RE: **Lot 20 Block 2 Unit 2 SAD 227**
5604 Kimberlite NW
Volcano Cliffs Subdivision
Grading and Drainage Plan
Engineers Stamp Date 10/11/18 (E10D052)

DRAINAGE AND TRANSPORTATION INFORMATION SHEET (REV 6/2018)

Project Title: 5604 Kimberlite NW Building Permit #: _____ Hydrology File #: _____

ENGINEER'S SEAL	Title 5604 KIMBERLITE NW	DRAWN BY
		DATE
10-18-18	GRADING AND DRAINAGE PLAN	Day
Richard Dourte P.E. #10854	<i>R.H.D. Engineering, LLC</i> 4305 Purple Sage Ave. NW ALBUQUERQUE, NM 87120 (505) 288-1621	SHEET # X of X
		JOB #

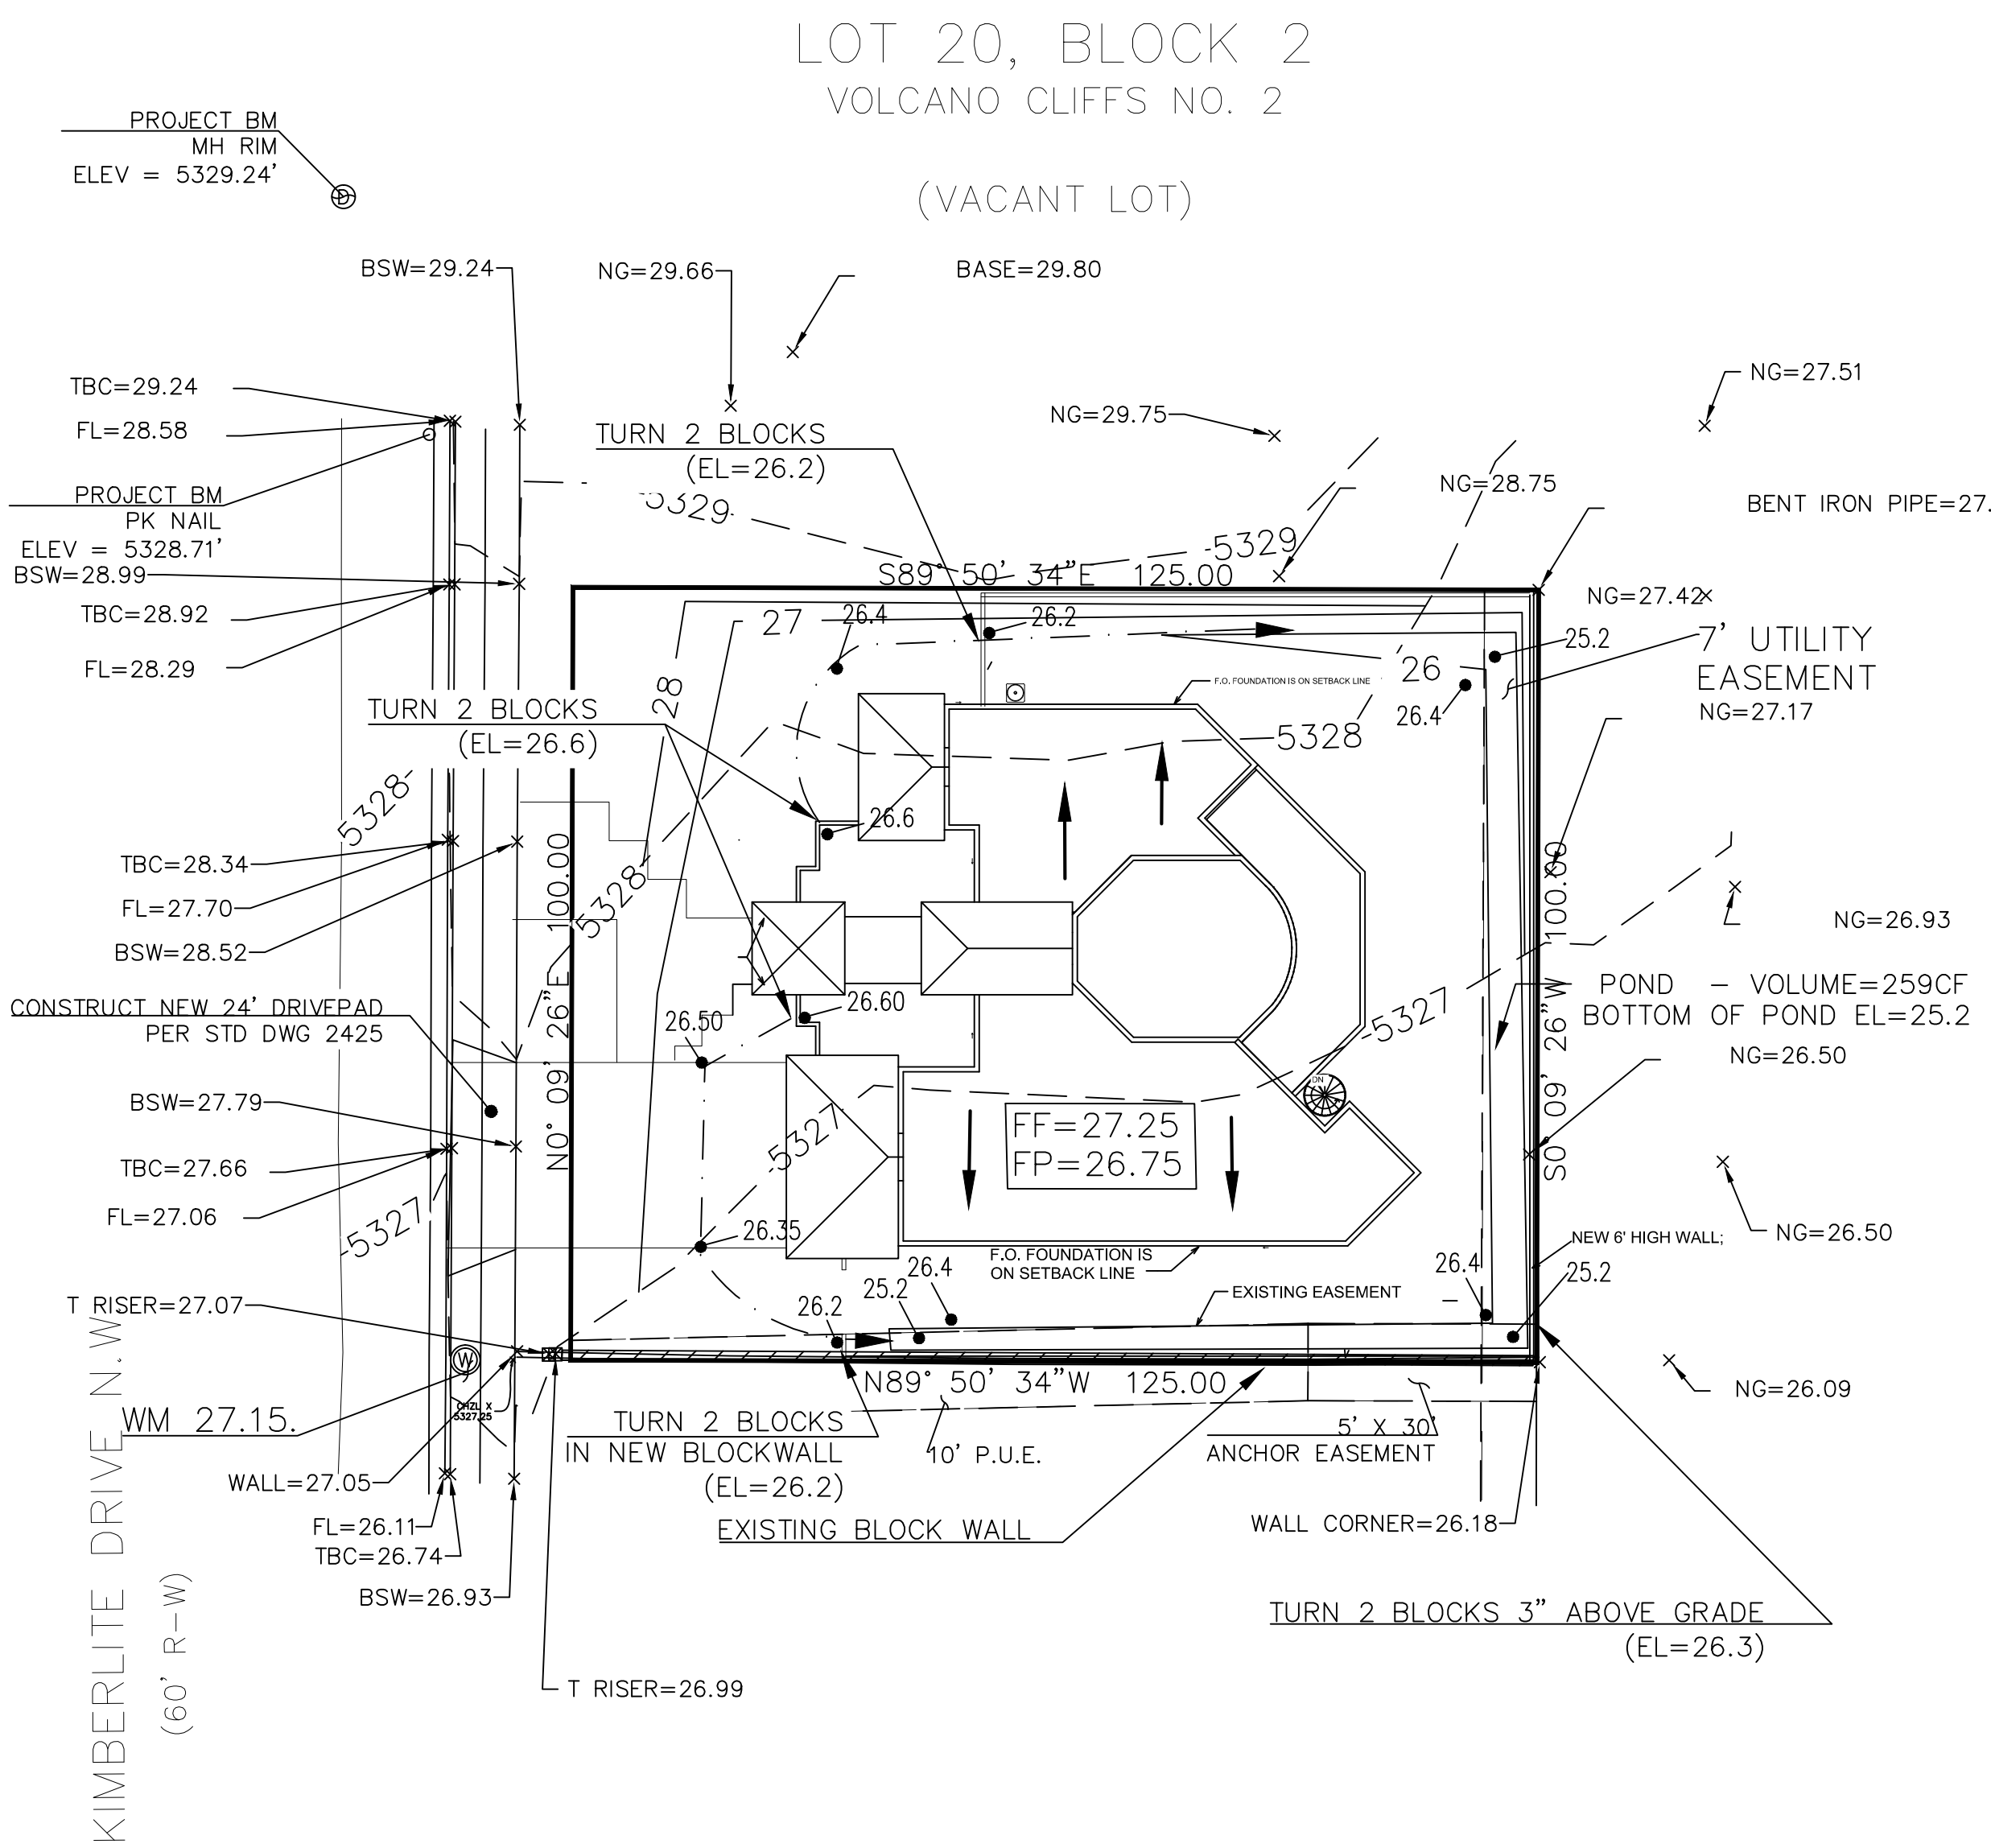
- Raise the FF pad above the BSW spot elevation so drive pad may drain toward street.
